Torque Converter Flex Lock-up Shudder

April 23, 2015 Rev2:

Some 2012 – 2014 Camry vehicles with a U760 transmission may exhibit a brief shudder intermittently while driving under light loads between approximately 25 and 50 mph. The torque converter and Engine Control Module/ECM (SAE term: Powertrain Control Module/PCM) logic have been modified to reduce the possibility of this condition occurring. Please follow the Repair Procedure below to address this condition.

Figure 1. Magnet Installation Locations

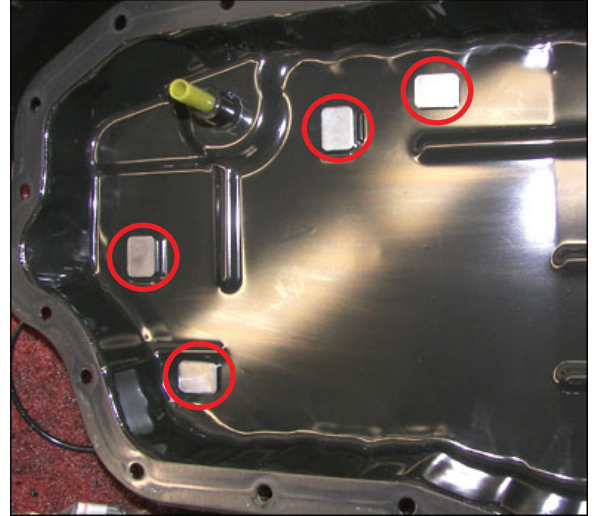
6. Install 4 NEW magnets in the locations shown in Figure 1.

Figure 2. Location of Authorized Modifications Label on 2012 – 2014 Camry

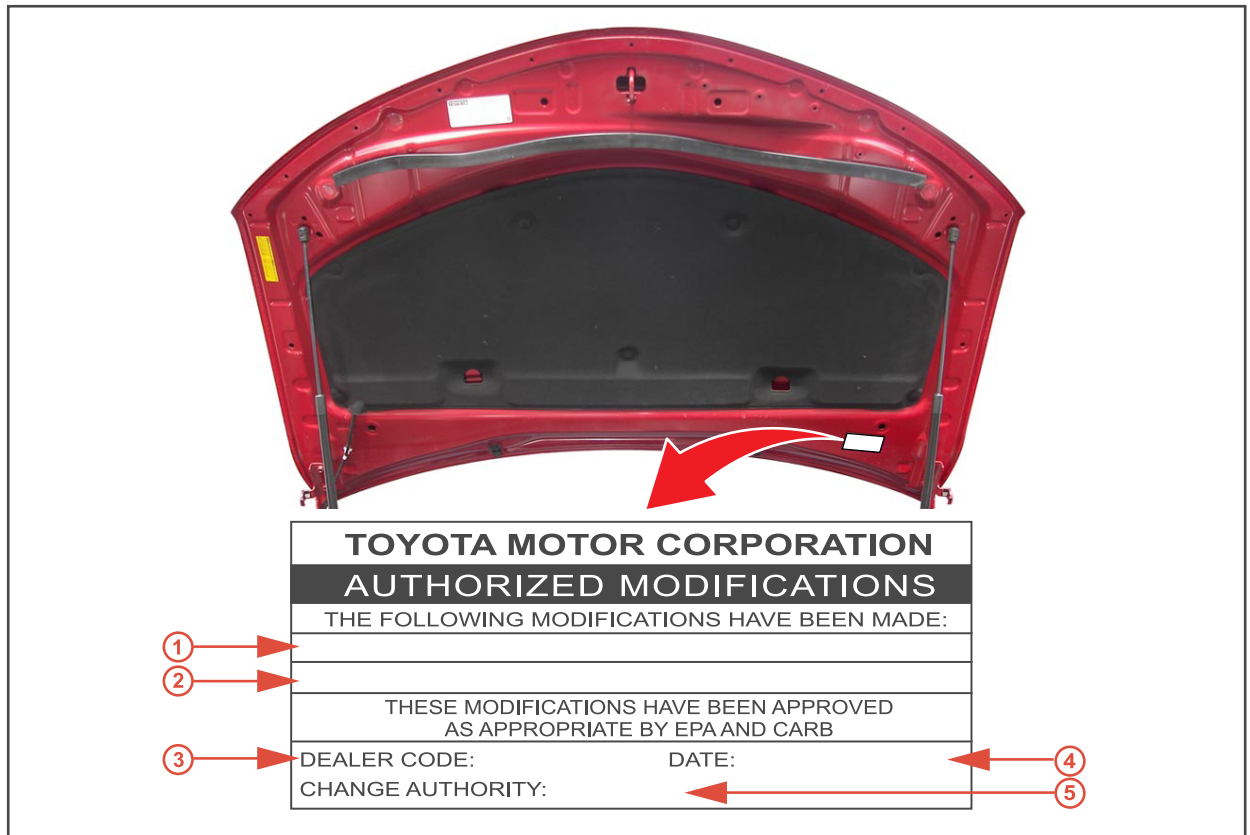
- Check for the Authorized Modifications Label affixed to the vehicle in the location shown in Figure 2 below. Confirm if the ECM (PCM) calibration has been updated. If the calibration ID listed is NOT the latest ECM (PCM) calibration — go to step 10. If the calibration ID is the latest, go to step 12.
